# Access Compliance Report

## Public Rights-of-Way

Intersection ID: 15555	Main Street: EASTOVER RIDGE DR	Cross Street: RANDOLPH RD	Location: N
ADA ID: 499B40AFAC73	Ramp Type: PerpDiag	Initial Pass/Fail: Fail	Overall Compliance: No
Codes/Mitigation Info/Possible Solution		Field Measurements/Component Compliance

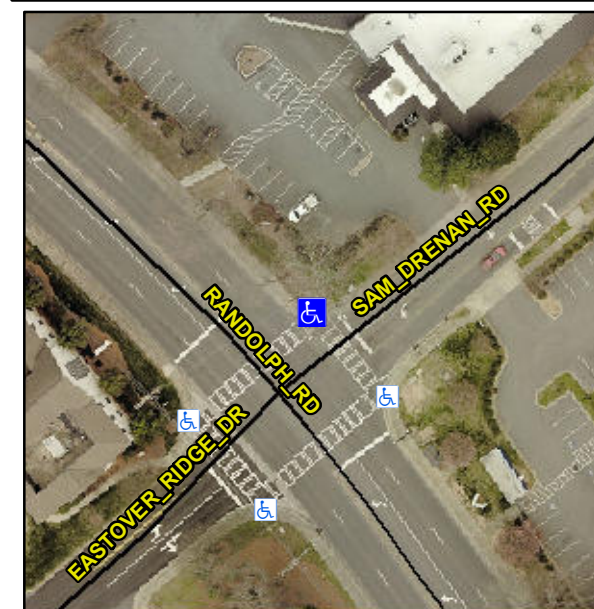
**R304.2.2, R304.5.3**

**Remove & Replace Curb Ramp With Two New Directional Ramps or Equivalent.**
